INITIAL FIRE SAFETY INSPECTION REPORT

ALIB Composite Ltd. (Extension)

RSC ID: 24564

Fire Safety Inspection Report

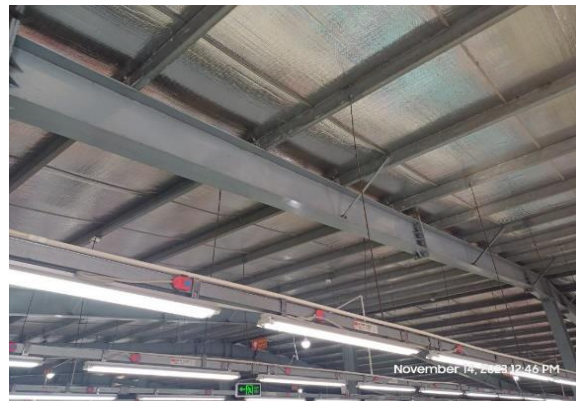
SI No.	Category	Findings	Required Action	Remediation Time Frame
F-1	Fire-Rated Construction	The main structural element of the building is constructed by steel element which is non-rated and were found in exposed condition without any fire protection. Location: Main Building	Interim building shall be type-1 or type-2 construction. Provide required fire rating on the structural elements by following Section 4.4 and Table 4.4.1 of the RSC Standard or Table 3.3.1 and Table 4.1.1 from BNBC Part 4.(2006). Consult a qualified fire protection engineer to design the rated construction barriers in between two floors and in structural members.	Within 6 months

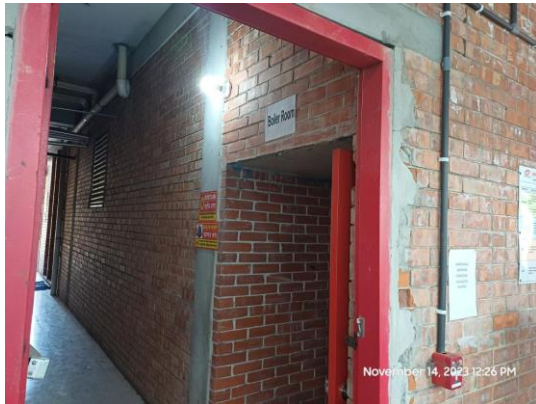
F-9	Means of Egress	The exit discharge path (passageway) is not properly protected due to power cable in the discharge passageway. Location: East side(near boiler, transformer) of main building.	Relocate the electrical power cables from the passageway ,Or protect the passageway from power cable by 1 hour fire rated construction.	Within 2 months
-----	-----------------	---	--	-----------------
